REQUEST FOR PROPOSAL NO. PS20210991 CONSULTING SERVICES FOR THORNTON PARK PUMP STATION UPGRADES

ADDENDUM NO.1

1.	<u>ADDED</u>	Thornton	Park Pui	mp Statior	ı Wet	Well	Condition	Assessmer	nt

TECHNIC	AL MEMORANDUM					
SUBJECT	Thornton Park Pump Station Wet Well Condition Assessment					
PROJECT	City of Vancouver Thornton Park Pump Station Repairs					
TO	Thomas Mah, PEng City of Vancouver	FROM	Stuart Fretwell, PEng			
DATE	28 July 2021	FILE REF	WSE File #165.300			
VERSION	A	STATUS	Draft

Figure 8: 100 mm dia. wet well flush pipes

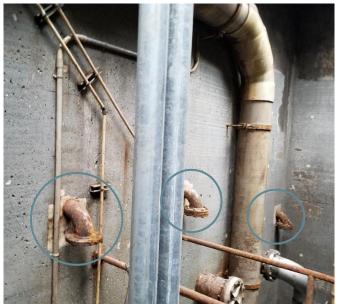
The 100 mm dia. wet well flushing pipes, shown in Figure 8, are in poor condition and appear to have been replaced since original construction based on the appearance of concrete patches. Two of the three pipes have been capped with blind flanges and do not appear to be in use. If the City intends to use the flushing pipes in

the future, the surface corrosion should be removed and the piping inspected and re-coated or the piping should be replaced with stainless steel.

Photo 4: One visible crack, west wall, upper portion.

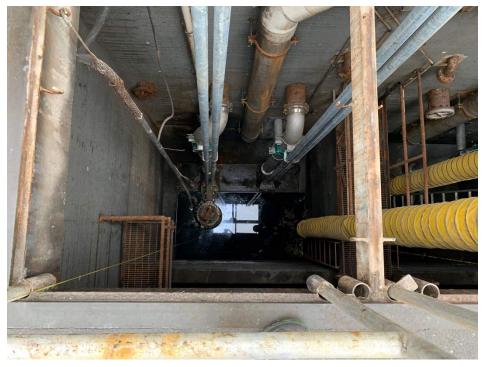
The only area of visible cracking to the concrete is on the upper half of the north wall, consisting of a vertical crack, with a width estimated at <0.5 mm (see Photo #4). There is no sign of efflorescence, water flow, rust staining or other visible deterioration to the crack or surrounding area. Based on the location and appearance, it is assessed to be a shrinkage crack and not a structural concern at this time.

Photo 6: Maximum observed erosion of concrete surface, lower walls of wet well

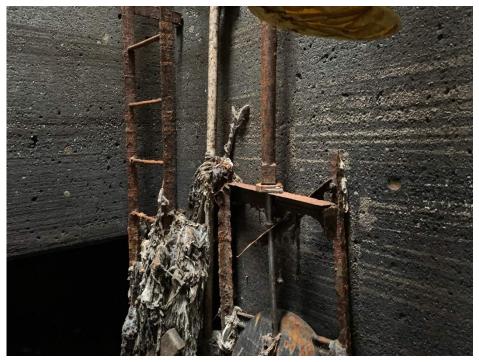
Below the wet well dividing wall, in the area close to the normal liquid level in the wet well, some areas of concrete have eroded to expose the aggregate. We estimate there is a maximum depth of erosion of around 5 mm (see Photo #6), due to exposure to effluent and/or scour. The remaining concrete appears sound, and the walls are still assessed to be in generally good condition.

Photo 10: Intermediate platform, guardrail in poor condition. Significant corrosion, complete loss of coating, potential section loss.

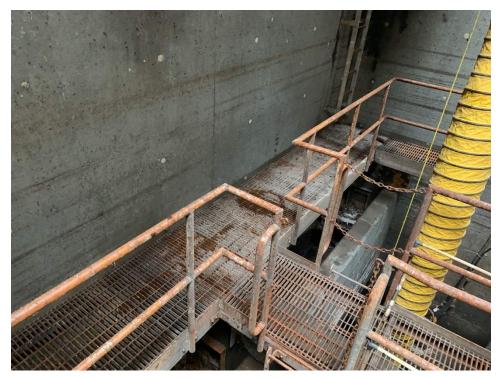
The guardrails for the intermediate platform are in fair to poor condition. They show extensive visible corrosion to some areas, particularly on the west side (see Photo #10), and likely have some section loss of structural steel to this area, although the thickness of remaining sound steel is unknown.

The ladders from the intermediate platform to the base of the wet well are in very poor condition. The west ladder has portions that have corroded full thickness with complete section loss (see Photo #12).

If the platforms are to remain in use, they should be rehabilitated by cleaning of corrosion product to sound metal, inspecting to confirm there is no significant section loss (particularly to the guardrails), and re-coated

with a suitable coating system. Alternatively, it may be more cost effective to replace with a new structure, ideally fabricated from 316 stainless steel or fiberglass to give improved durability.

The lower ladders to the wet well are in very poor condition and should be removed and, if required, replaced with new ladders fabricated from 316 stainless steel or fiberglass, suitable for the exposure conditions inside the wet well.
